# GVT Bus Storage & Maintenance Facility

**FCI Constructors, Inc.**  
Request for Information 003  
Detailed, RFIs Grouped by RFI Number with Cost

<b>CNG Maintenance Building</b> 333 West Avenue, Grand Junction, CO	<b>Project #</b> 10-12-016 Tel: tbd Fax: tbd	<b>FCI Constructors, Inc. - GJ</b>
<b>RFI #:</b> 003	<b>Answered By:</b> Justin Mendenhall	<b>Date Created:</b> 8/13/2012
<b>Author Company:</b> FCI Constructors, Inc. - GJ P. O. Box 1767 Grand Junction, CO 81502	<b>Author Company:</b> FCI Constructors, Inc. - GJ P. O. Box 1767 Grand Junction, CO 81502	<b>Author By:</b> Justin Mendenhall
<b>Co-Respondent:</b>	<b>Author RFI Number:</b>	
<b>Subject:</b> Phone & IT Conduit Locations	<b>Discipline:</b> Architectural/Electrical	<b>Category:</b> Clarification
<b>Company Name:</b> Magnum Electric Co, Inc.	<b>Contact Name:</b> Jeff Anderson	<b>Telephone Number:</b> 970-243-9855
		<b>Fax Number:</b> 970-243-1458
<b>Cost Impact:</b> No	<b>Drawing Impact:</b> Yes	<b>Schedule Impact:</b> No
<b>Question:</b>		<b>Date Required:</b> 8/20/2012
<b>Reference Drawing(s):</b> A1.0

**FLEET SERVICES**  
MAINTENANCE BUILDING & RETRO-FIT  
RFP-3410-12-DH

1 FLOOR PLAN  
A1.0 1/4" = 1'-0"

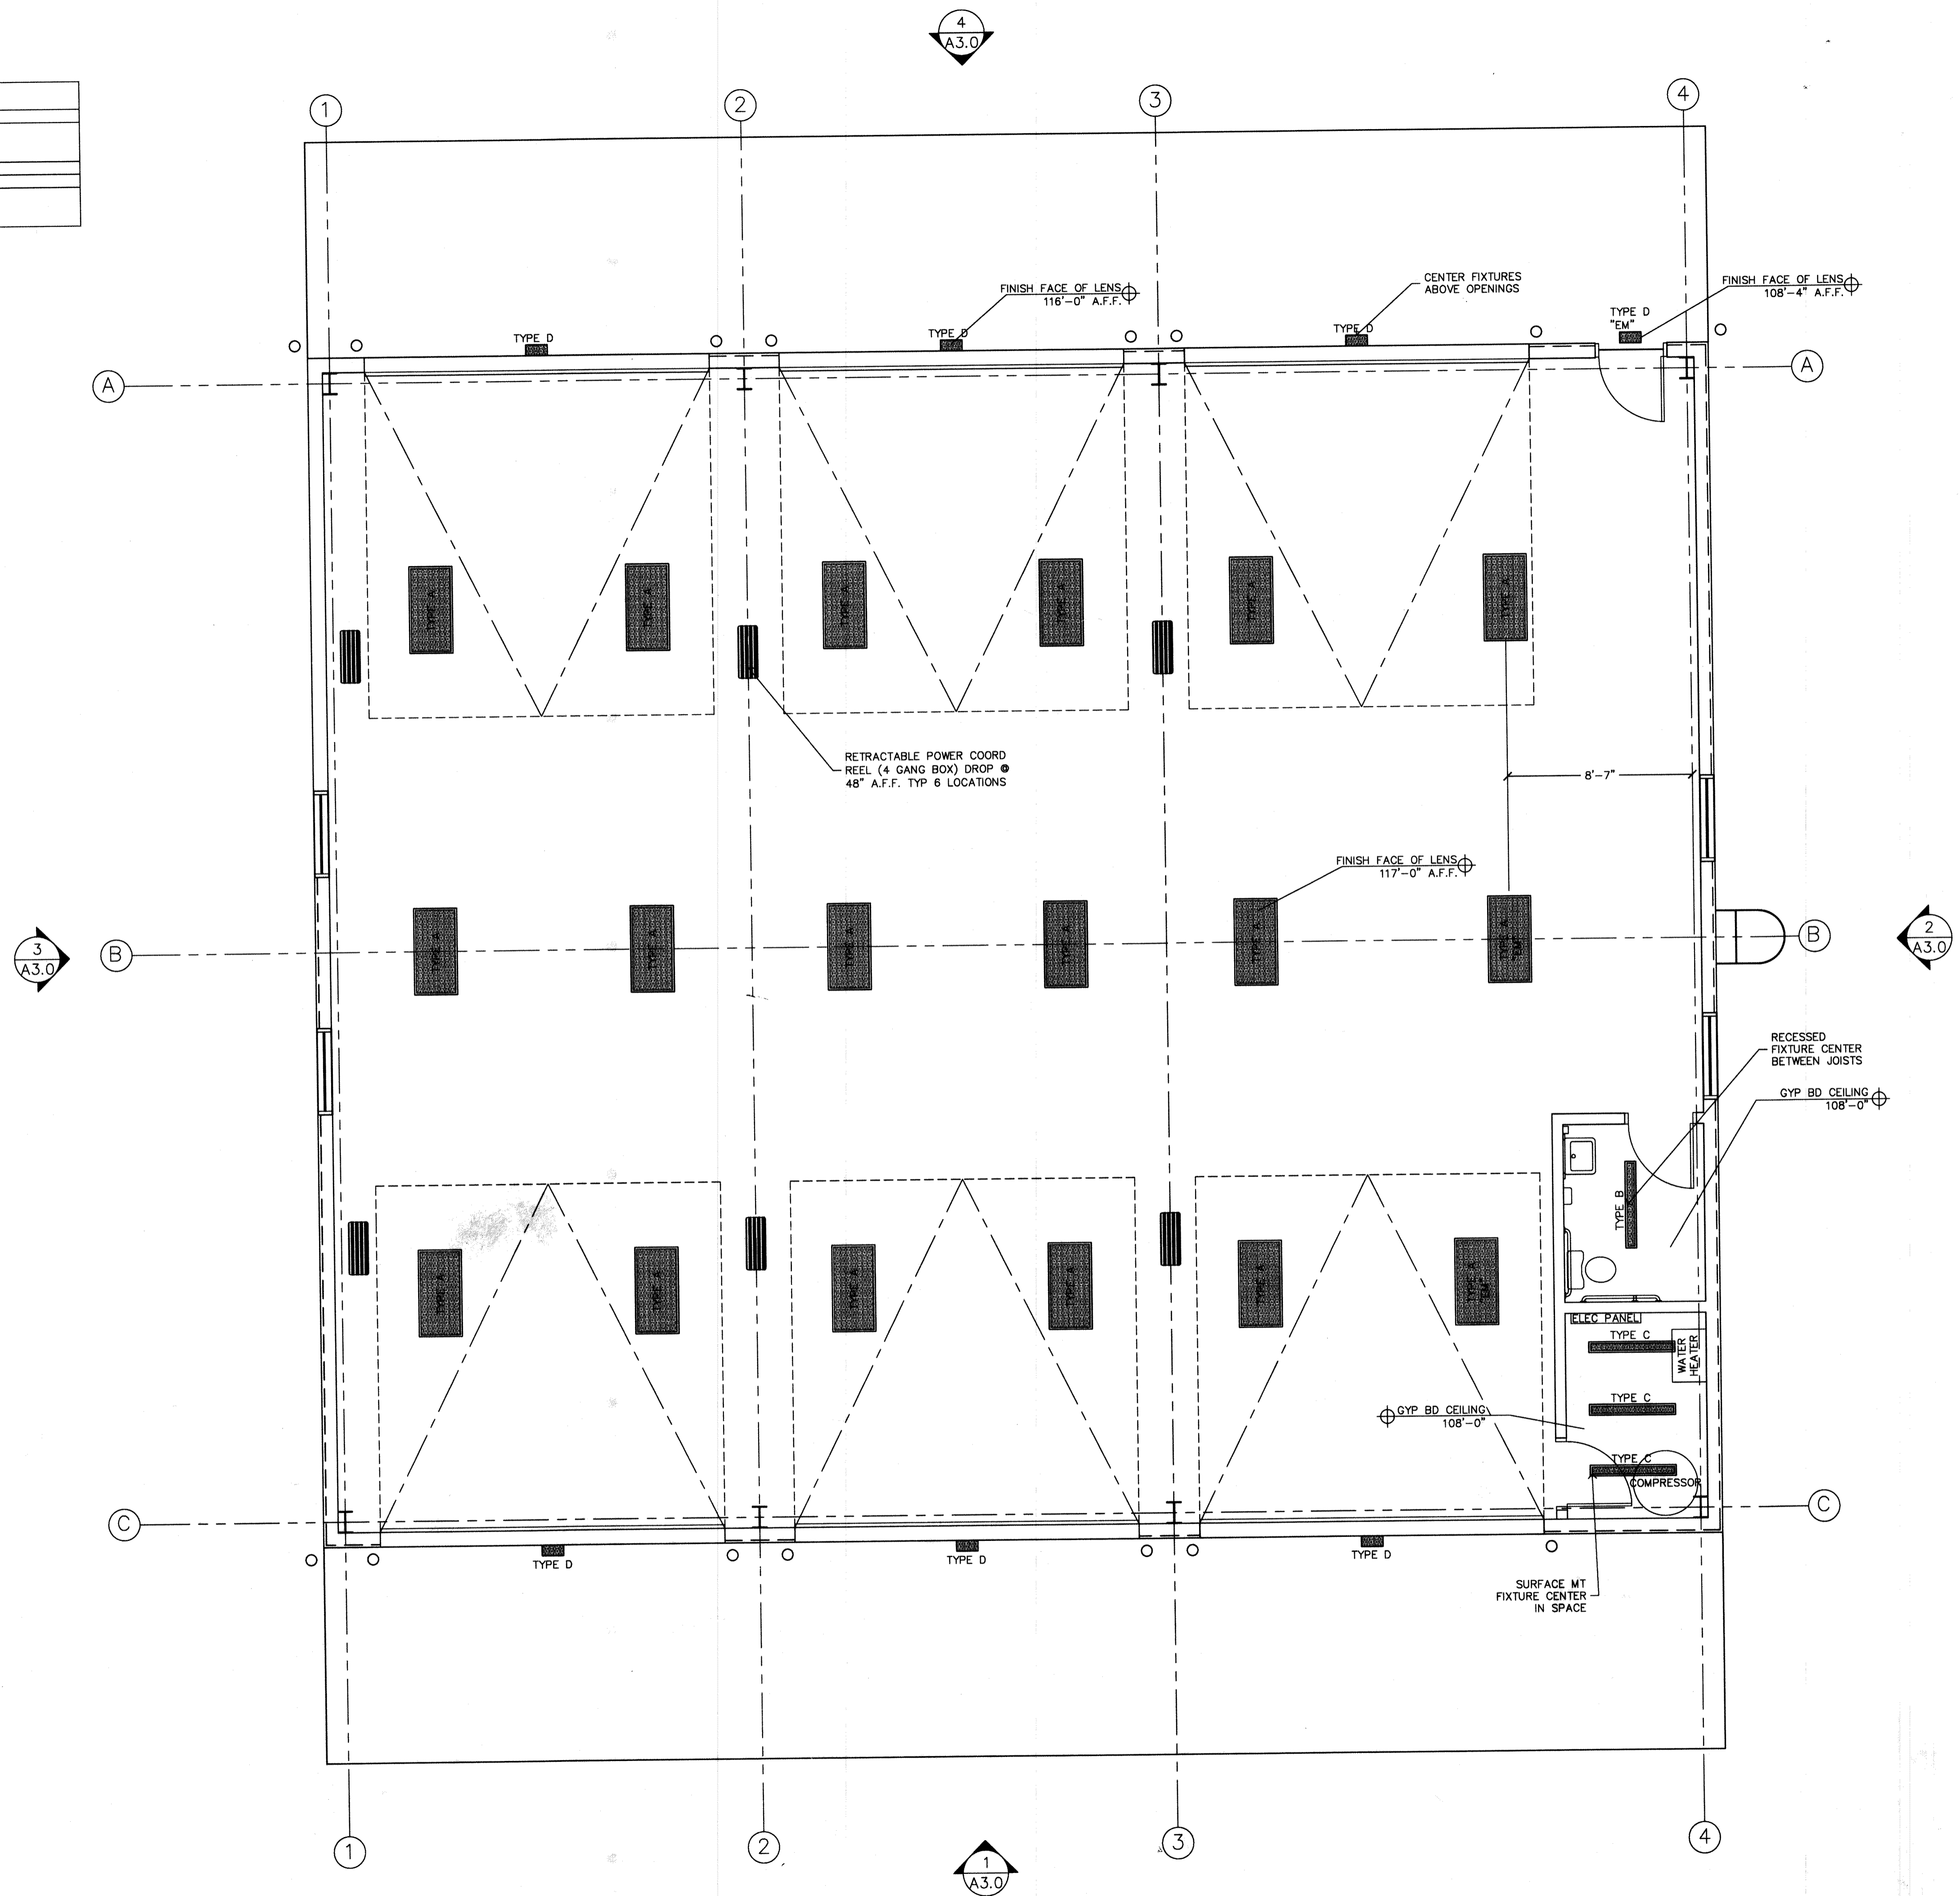
<b>As discussed on site during the 8.7.2012 OC Meeting, shift the (3) 4" future IT conduits East so that they are 13' from the NorthEast building corner. 2" conduit for phone service will not be ran under ground, conduit is to be ran overhead.</b>		
<b>Suggestion:</b>		
<b>Answer:</b>		<b>Date Answered:</b> 8/13/2012
<b>This is for documentation only, no response is required.</b>

**PLUMBING PLAN**  
SCALE: 1/4"=1'-0"  
NORTH

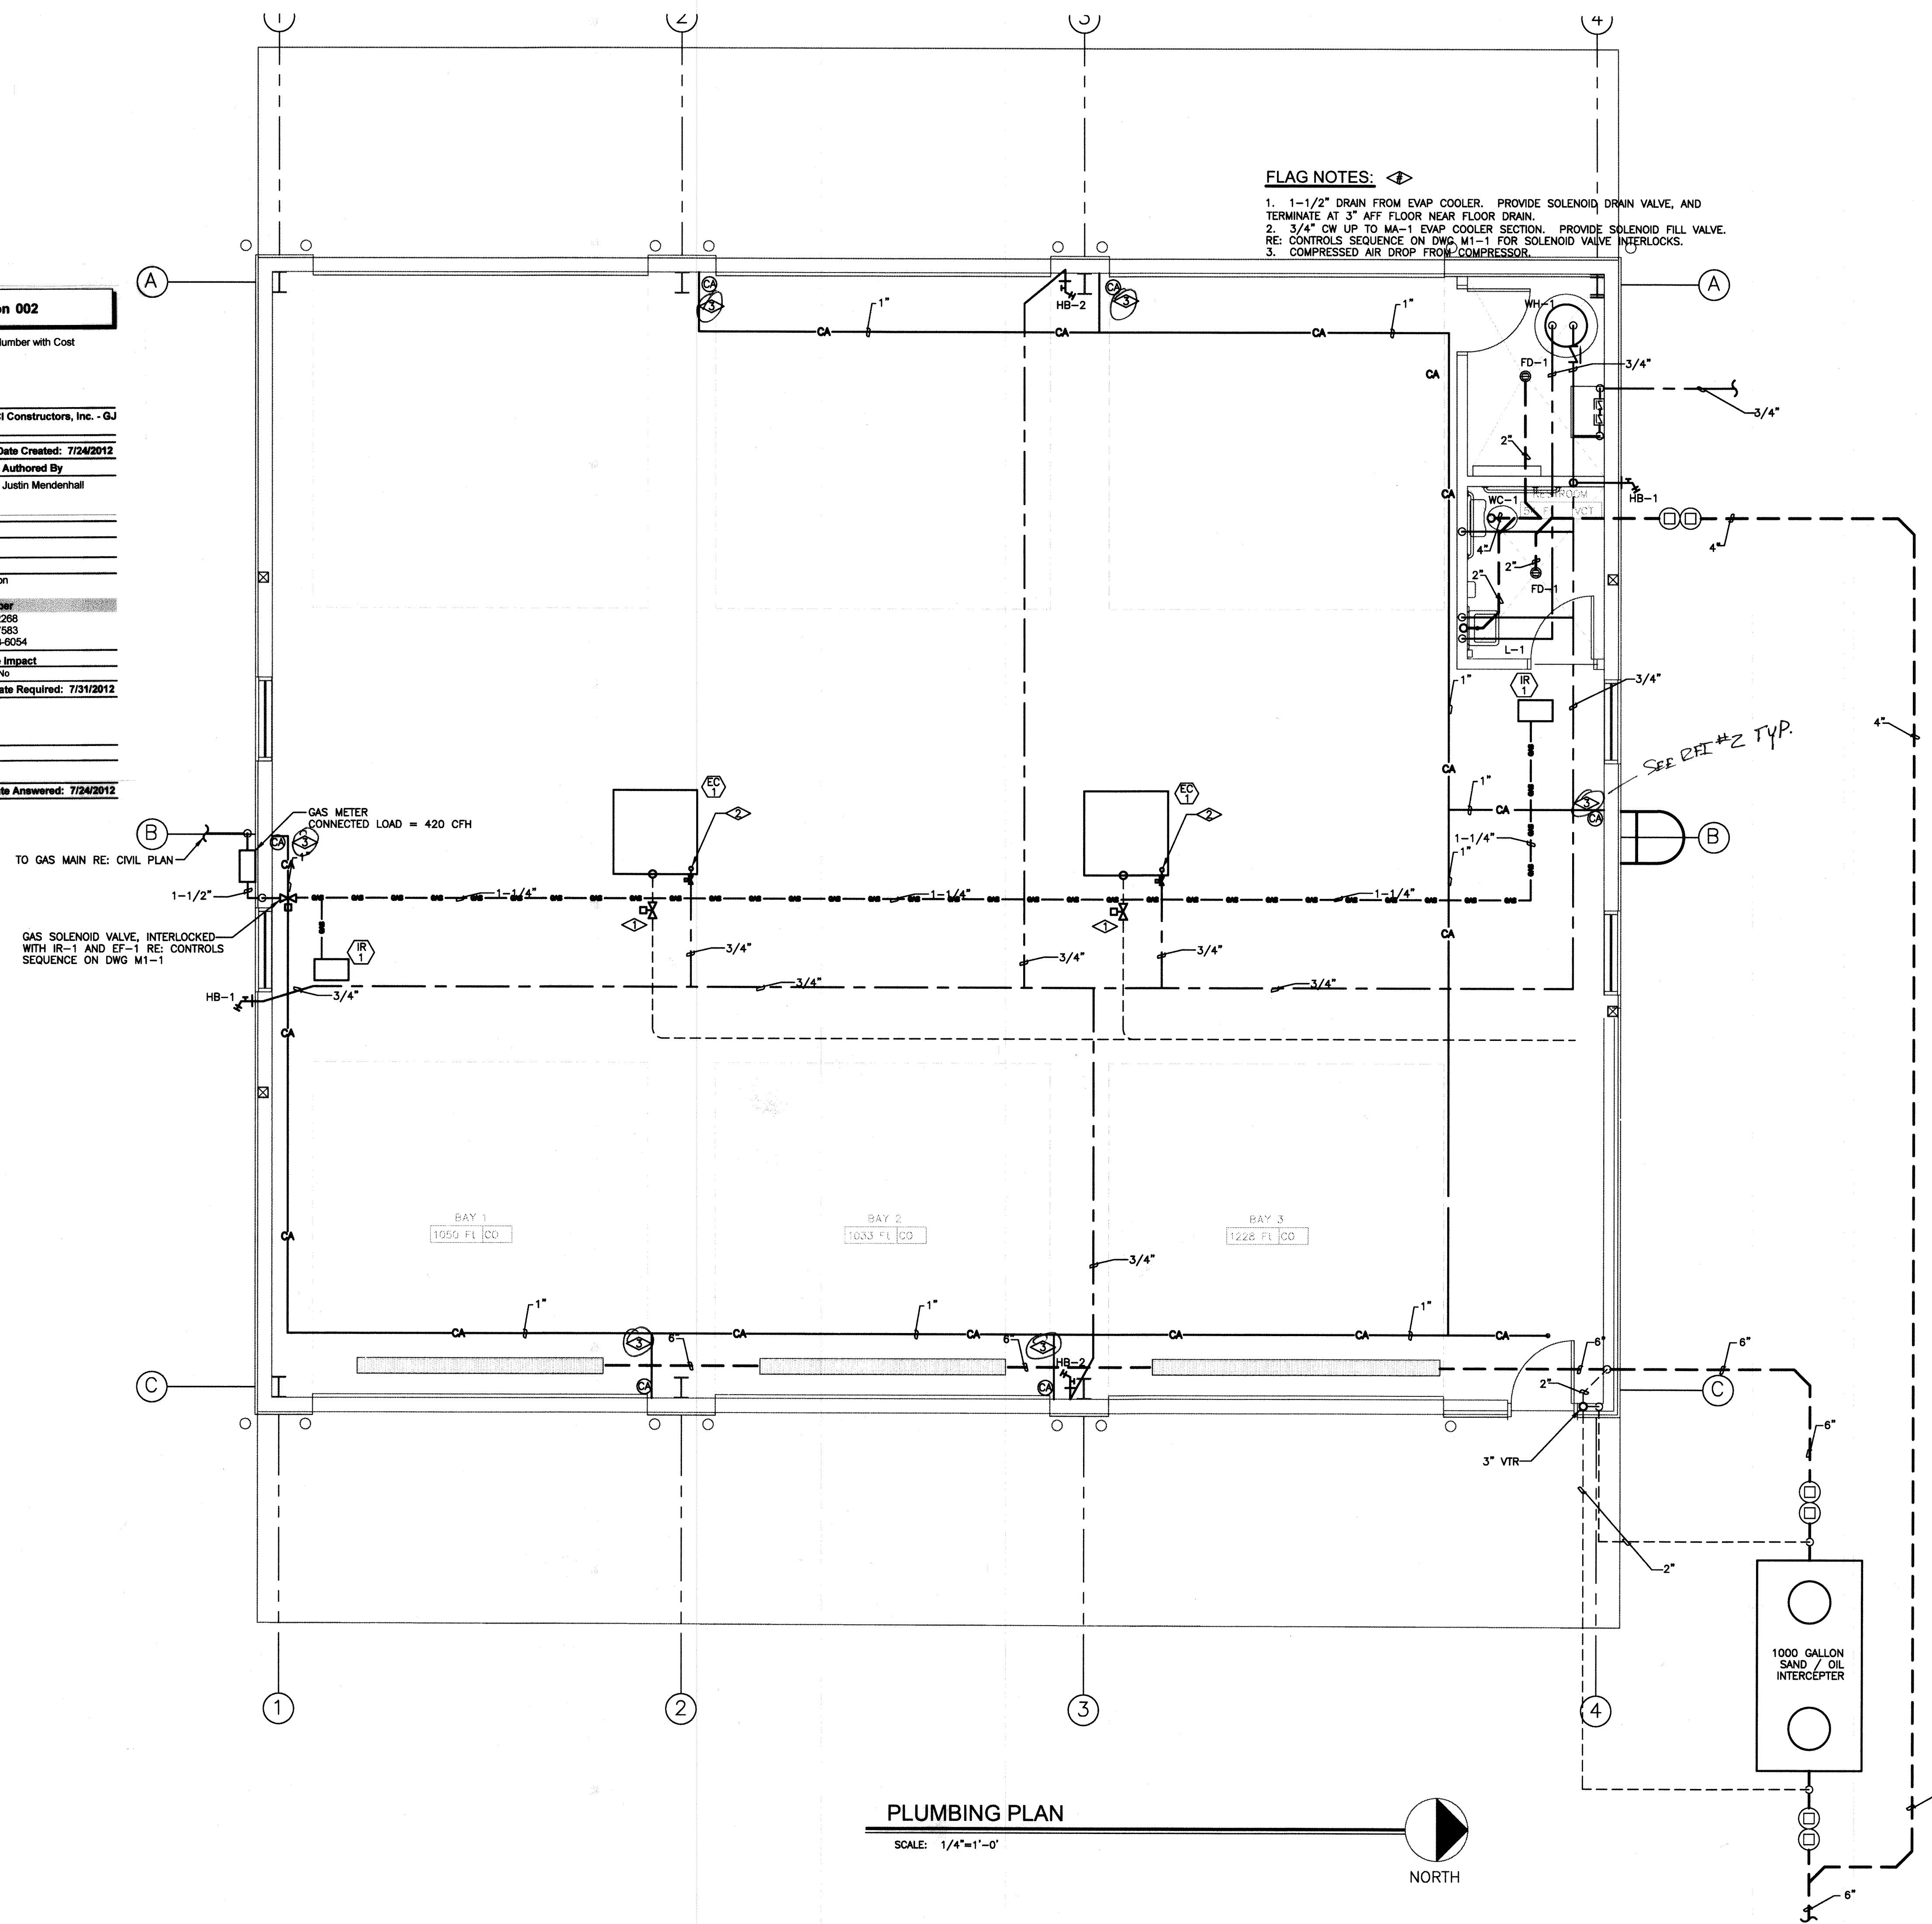
Compressed air distribution lines will be 3/4" in lieu of 1".

This is for documentation only, no response is required.
